J1647-02-01
August 9, 2019

Re: Peer Review Comments
Brigati Village Slope Project
41 Church Street
Grafton, Massachusetts

O'Reilly, Talbot & Okun Associates, Inc. (OTO) is pleased to provide this letter report summarizing our geotechnical engineering peer review comments for the proposed Brigati Village development, to be located at 41 Church Street in Grafton, Massachusetts.

TITLE:
GRADING AND
DRAINAGE PLAN

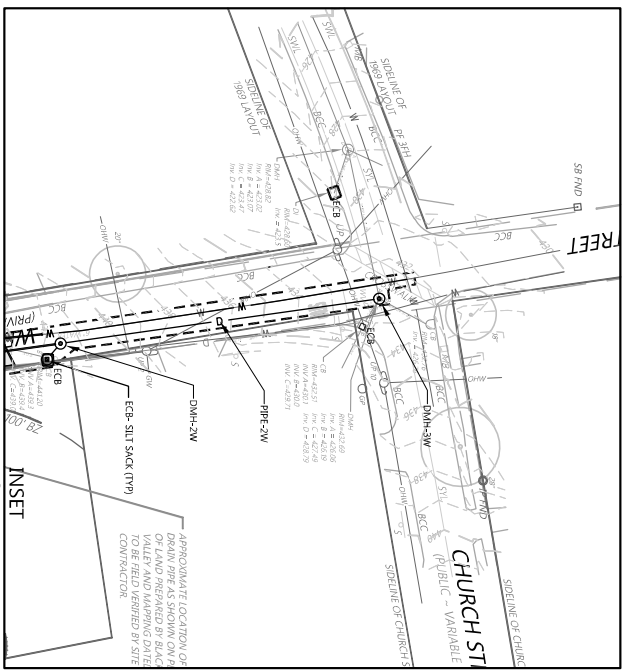
We note that the detail provided on Sheet C5.04 does not depict actual construction details. As depicted on Sheet 3.02 below the embankment the solid drainpipe flows through drain manholes and eventually discharges through a flared end section. The solid pipe from Basin 1 flows through three manholes and eventually discharges into the level spreader approximately 120 feet to the west of the basin. The solid discharge pipe from Basin 2 flows through one manhole and discharges into the riprap lined swale to the southwest of the basin.
